HERARD RESIDENCE
 INTERIOR & EXTERIOR
 RENOVATIONS &
 ADDITIONS

AMENDED SITE PLAN	2/20/24
SITE PLAN REVISIONS	11/17/23
ISSUED FOR BUILDING PERMIT	7/5/23
ISSUED FOR PB SIGNATURE	6/22/23
REVISIONS FOR PB MEETING	6/21/23
PLANNING BOARD SUBMISSION	4/4/23

DRAWING TITLE
**AMENDED SITE PLAN,
 BULK TABLE**

SP-1

3 PROPOSED SITE PLAN

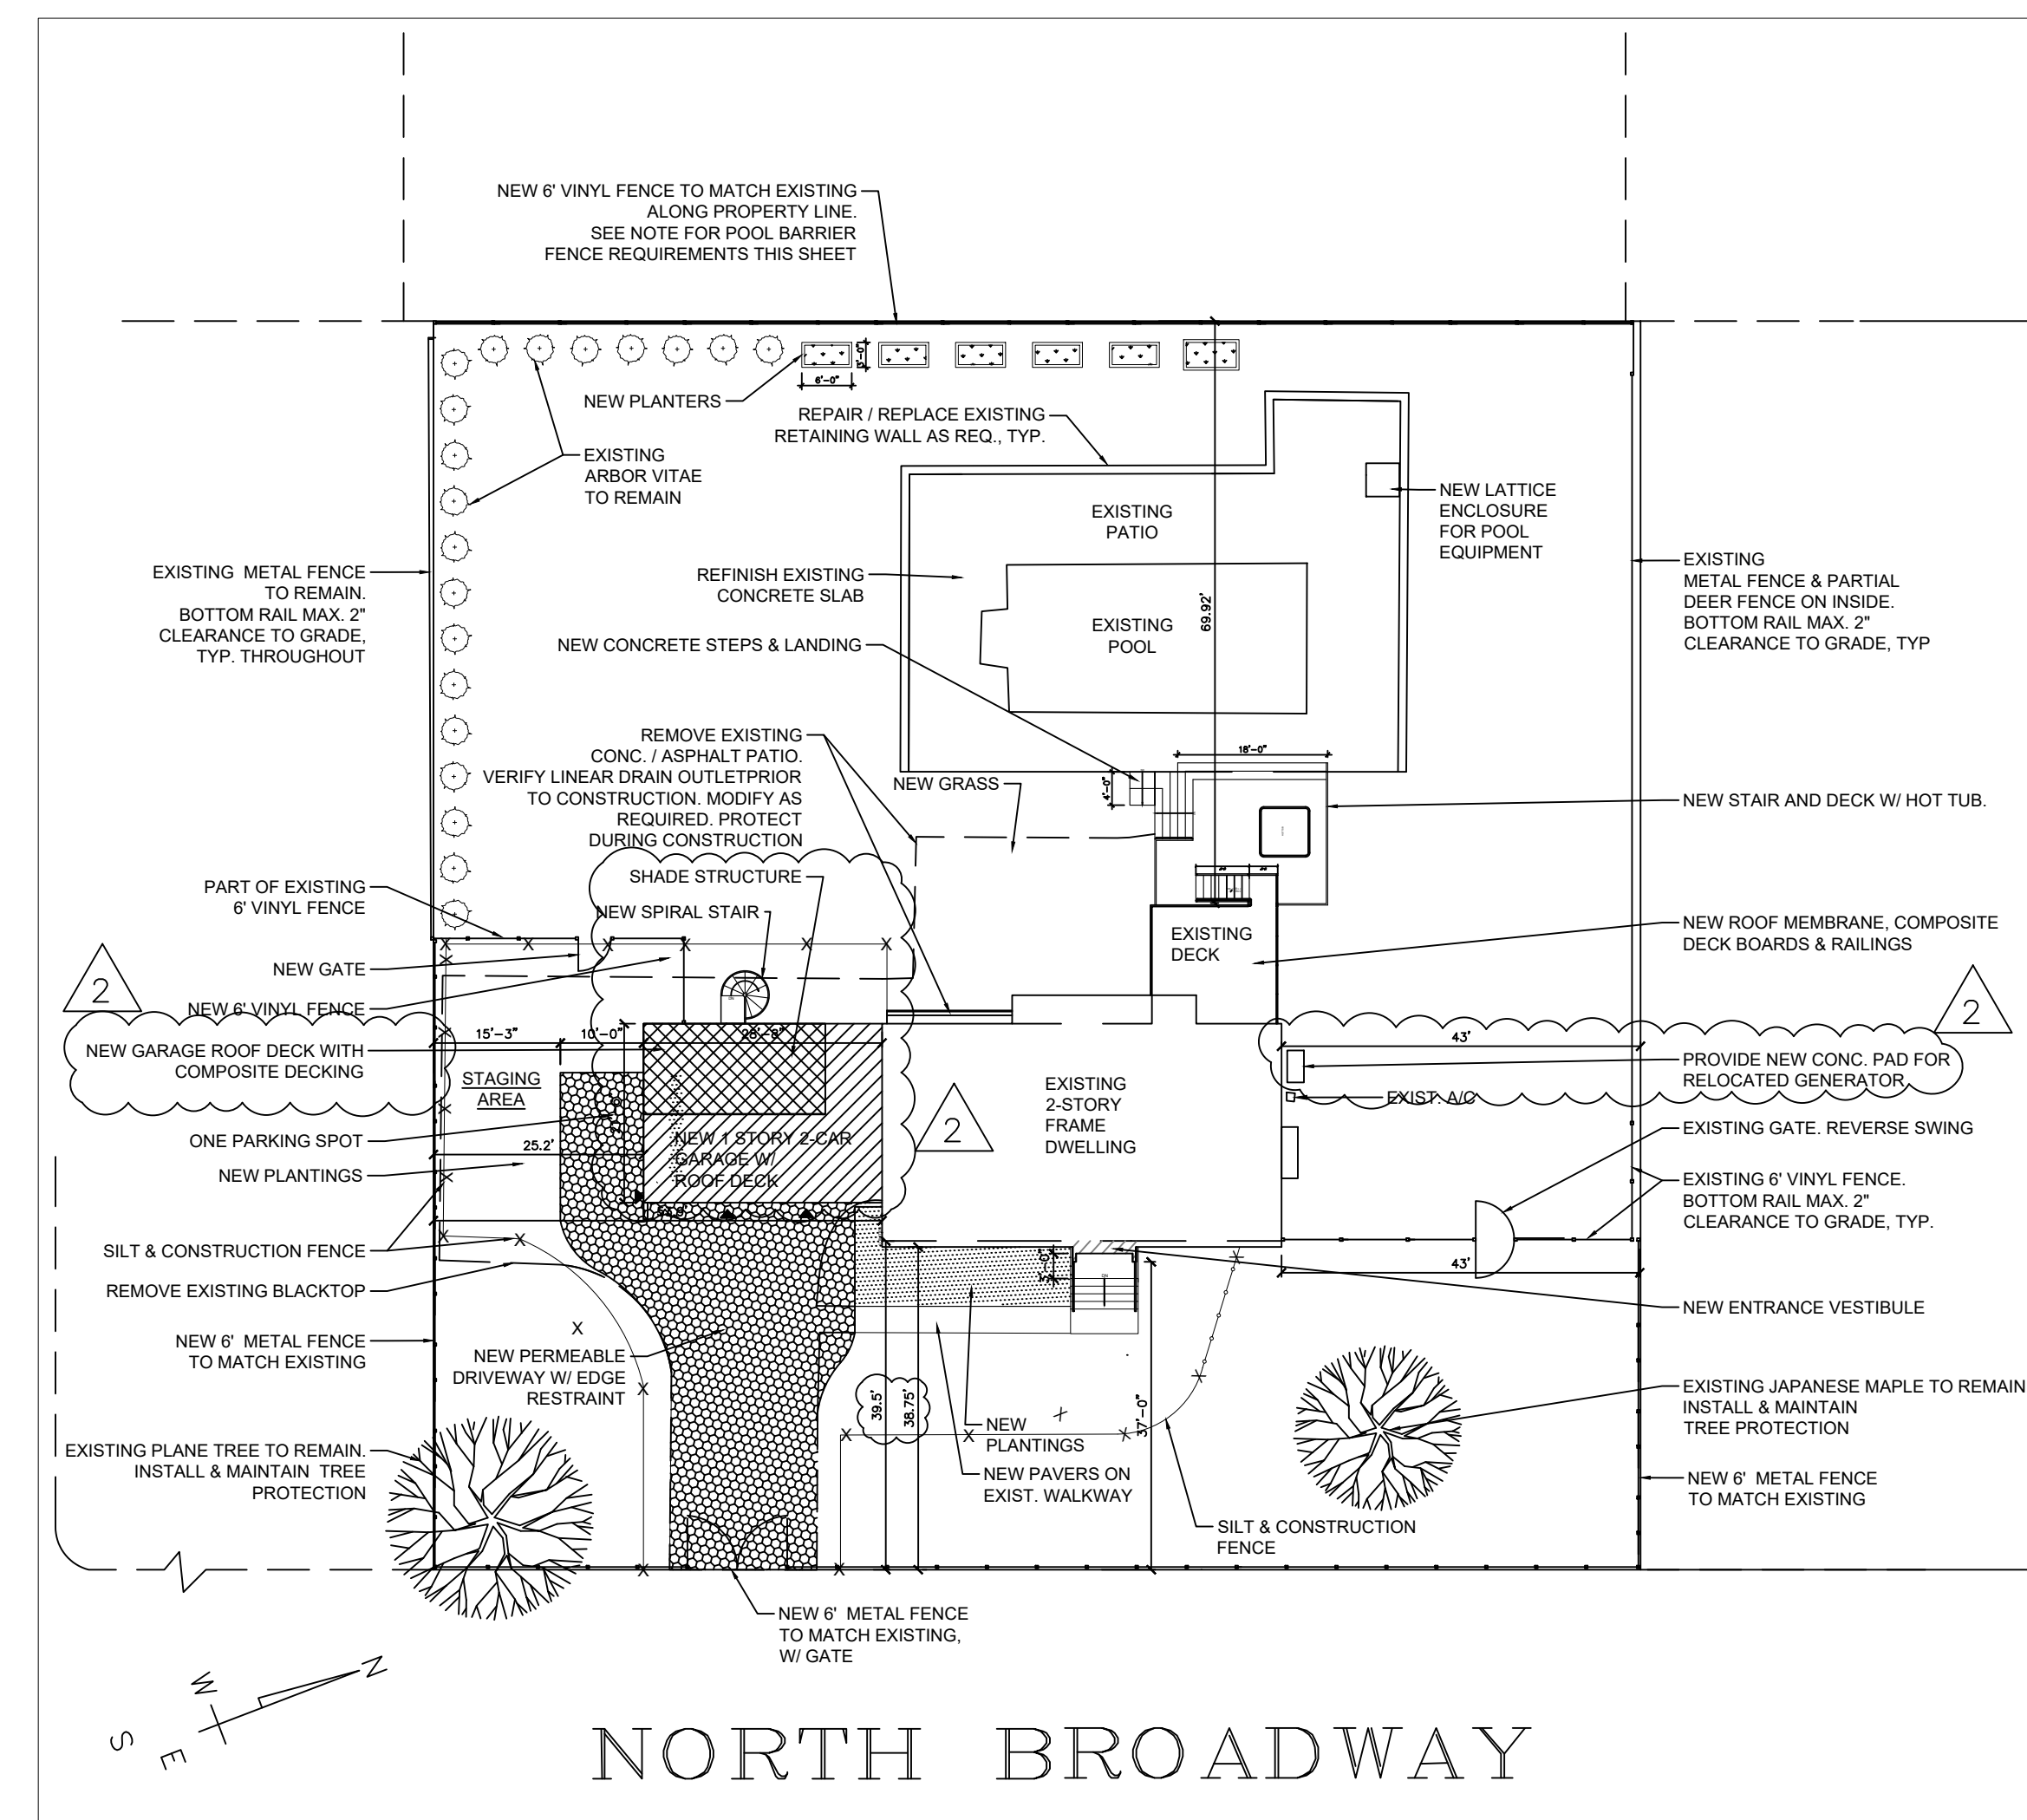
REVISION NOTE 1:
 THE PREVIOUSLY APPROVED SITE PLAN HAS BEEN REVISED TO SHOW A NEW DECK WITH HOT TUB AND A NEW STAIR TO REPLACE THE EXISTING BETWEEN THE POOL AND THE STORAGE STRUCTURE WITH THE EXISTING DECK ON TOP. THE PROPOSED SPIRAL STAIR HAS BEEN REPLACED WITH A WOODEN LINEAR STAIR IN THE SAME LOCATION AS THE EXISTING STAIR.

REVISION NOTE 2:
 THE PREVIOUSLY APPROVED SITE PLAN HAS BEEN REVISED TO SHOW A NEW ROOF DECK WITH SHADE STRUCTURE ABOVE THE NEW GARAGE AND A NEW SPIRAL STAIR TO THE BACK YARD. THE GENERATOR HAS BEEN MOVED TO THE NORTH SIDE OF THE HOUSE.
